DATE: May 18, 2016

TO: Design Review Commission
FROM: Sean K. Gallegos, Assistant Planner
SUBJECT: 16-SC-08 – 581 University Avenue

RECOMMENDATION:

Approve design review application 16-SC-08 subject to the listed findings and conditions

Tree #2

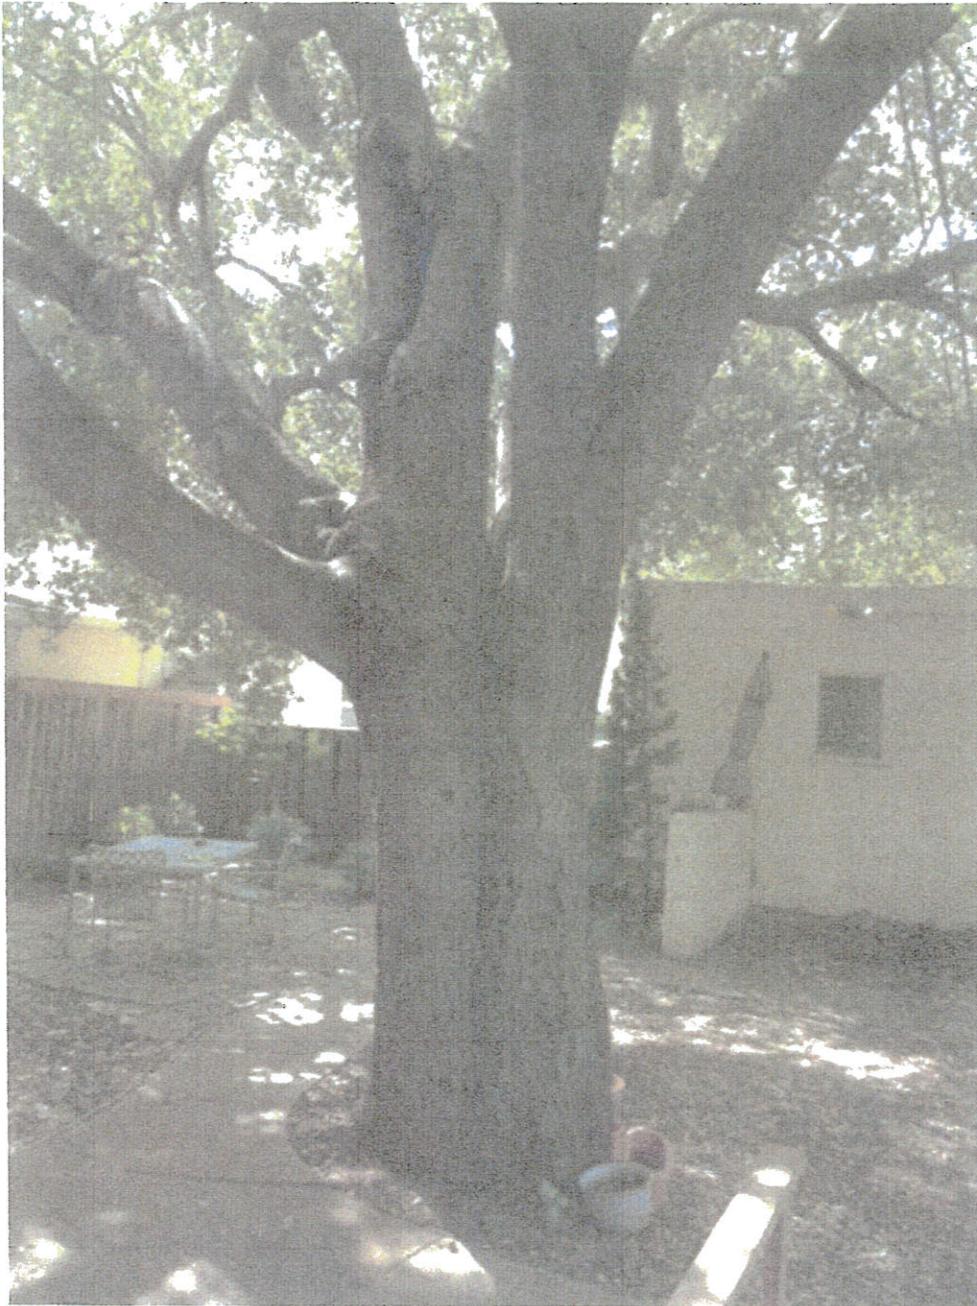
Like the smaller oak on the alley, this 35" DBH coast live oak tree was not pruned for structure when young. Unlike oak #3, intervention cannot now make this a reasonably safe tree. It is now a very large tree 50' wide by 36' tall, with multiple, serious structural problems. Because of these problems, there are multiple ways in which this tree could structurally fail. Due to the trees large size and its proximity to the home and yard, any failure could be catastrophic, causing significant damage to structures and serious injury or death to people nearby. This tree was rated F or poor for structure. It is hazardous and should be removed. The tree's main structural issues are pictured and described on the following pages.

1. This tree or its major leaders could fail at any time due to poorly attached leaders and a large hollow. It is in close proximity to the home and garage on site and overhangs virtually all of the rear yard.
3. The lot is flat. The tree's removal will have no effect on erosion, soil retention or water drainage in the area.
7. There are no reasonable and feasible ways to ensure the safety of this tree.

Tree Protection Plan Diagram - 581 University Ave, Los Altos CA

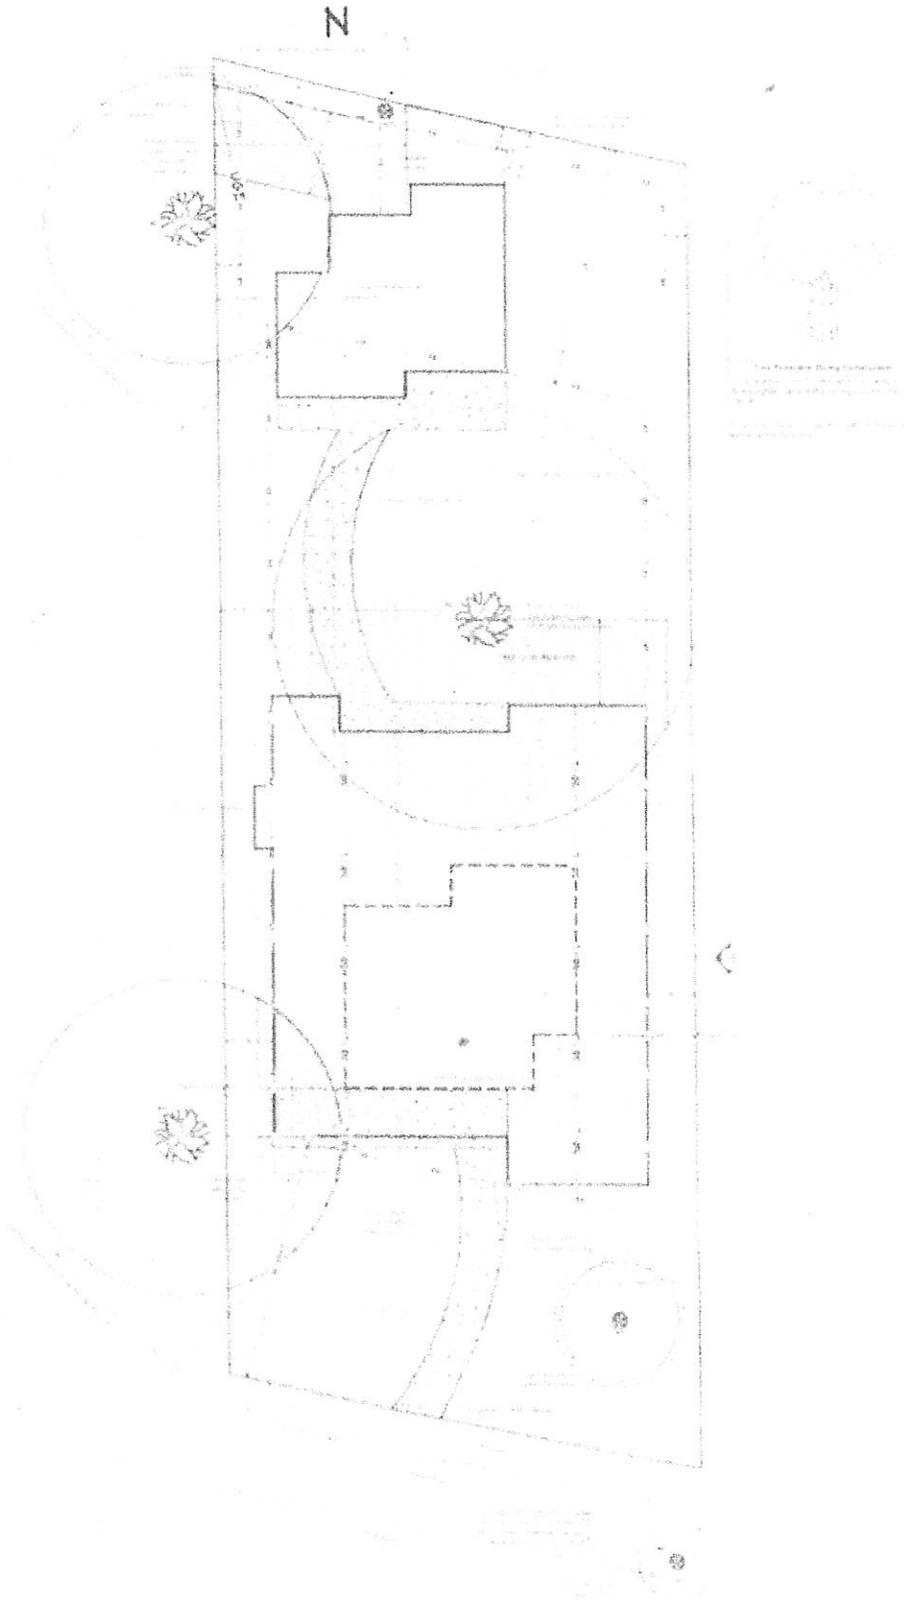
Tree #4: coast redwood, 33" DBH, 24'w X 95'h. Health =B, Structure= A, TPZ = drip line or minimum 16.5' in all directions from the trunk (on the project site). Protective fencing must be placed where possible given buildings and other impediments. When the project has commenced to the point that the fencing needs to be moved back in order to provide work area and construction of approved intrusions into the TPZ, the project arborist must be on-site to supervise the moving and re-anchoring of the tree protection fencing. Any pruning needed for construction clearance must be done by a company with a certified arborist on staff.

This tree is located about 30" from the property line on the adjacent property and overhangs the subject property by about 12'. The nearest edge of the basement/shoring excavation for the home at 581 University Avenue is 7'6" from the trunk of this tree. This excavation will remove approximately 6% of the tree's roots and will not significantly impact the tree's health. Roots larger than 2" diameter must be cut off cleanly at the edge of the excavation, covered with burlap and kept moist until the excavation is backfilled. Fencing, mulching and irrigation of the tree as recommended under General Tree Protection Plan should be followed.

Tree #5: coast redwood, 3" DBH, 22'w X 100'h. Health =B, Structure= A, TPZ = drip line or minimum 15' in all directions from the trunk (on the project site). Protective fencing must be placed where possible given buildings and other impediments. When the project has commenced to the point that the fencing needs to be moved back in order to provide work area and construction of approved intrusions into the TPZ, the project arborist must be on-site to supervise the moving and re-anchoring of the tree protection fencing. Any pruning needed for construction clearance must be done by a company with a certified arborist on staff.

This tree is located about 6" from the property line on the adjacent property and overhangs the subject property by about 12'. The nearest edge of the foundation excavation for the home at 581 University Avenue is about 7' from the trunk of this tree. This excavation and the excavation needed for the parking area will impact about 14% of the tree's root zone, which will not significantly impact the tree's health. Roots larger than 2" diameter must be cut off cleanly at the edge of the excavation, covered with burlap and kept moist until the excavation is backfilled. Fencing, mulching and irrigation of the tree as recommended under General Tree Protection Plan should be followed. Please see diagram on page 14.
